UNITED STATES PATENT AND TRADEMARK OFFICE
CERTIFICATE OF CORRECTION

PATENT NO. : 7,428,260 B2
APPLICATION NO. : 10/697853
DATED : September 23, 2008
INVENTOR(S) : Daniel Yellin

Fig. 2

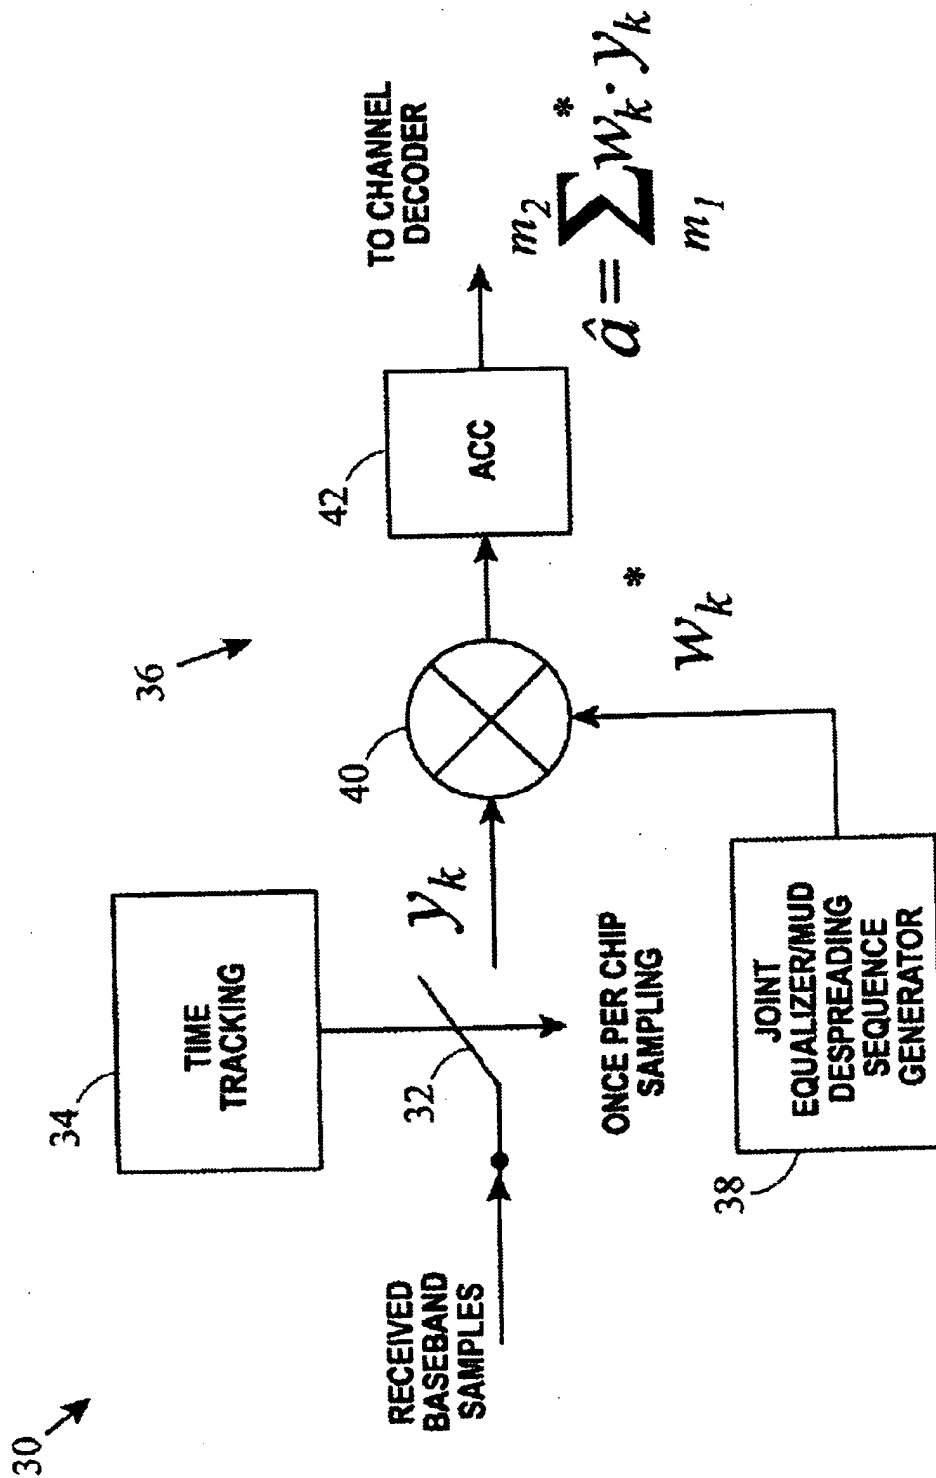
Delete Drawing Sheet 2 and substitute this figure therefor the drawing should be:
